# UNITED STATES PATENT AND TRADEMARK OFFICE

**Office Action Summary**

This is the **Final Office Action** for application number 10/801,842 Electronic Device Cradle Having Replaceable Latches, filed on 3/16/04. Claims 1-19 are pending. Claims 10-19 are withdrawn. This **Final Office Action** is in response to applicant's reply dated 6/8/06. The text of those sections of Title 35, U.S. Code not included in this action can be found in a prior Office action.

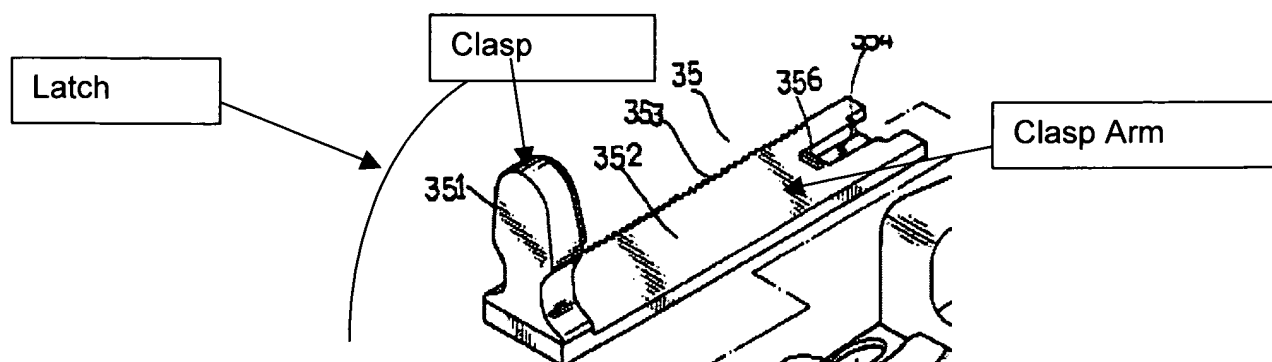
Claims 1-9 are rejected under 35 U.S.C. 102(e) as being anticipated by United States Patent No. 6816713 to Chen.

The patent to Chen discloses a cradle (10, 20) and latch assembly having a body (10, 20), the body having at least one pocket (21), at least one latch aperture (241) and a latch (35) detachable from the body, the latch having a clasp (351) and a means for coupling (353, 354, 356) to the body and a clasp arm (352) having a clasp arm length wherein the latch (35) is detachable from the body (10, 20) wherein the clasp extends in a non-coplanar angle from a portion of the clasp arm.

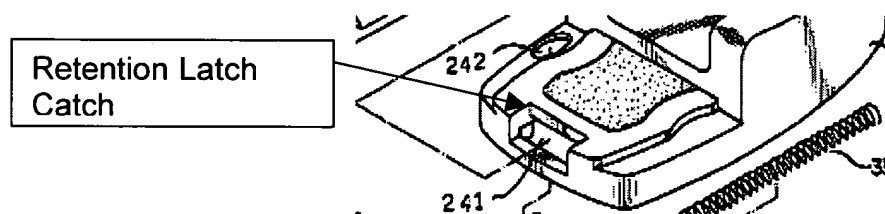
Chen also discloses wherein the means for coupling includes a retention latch arm (354) and a retention latch (356), wherein the retention latch arm (354) acts as a cantilever beam and wherein the latch has a thumb release (31), a stabilizing support (33) and a rear support (36) and wherein the body has a retention latch catch (the upper lip of the area surrounding the latch aperture, which catches the retention latch 356, See Drawing Below), a rear support recess (11), a latch guide (246) and a rotation support (22, 23).
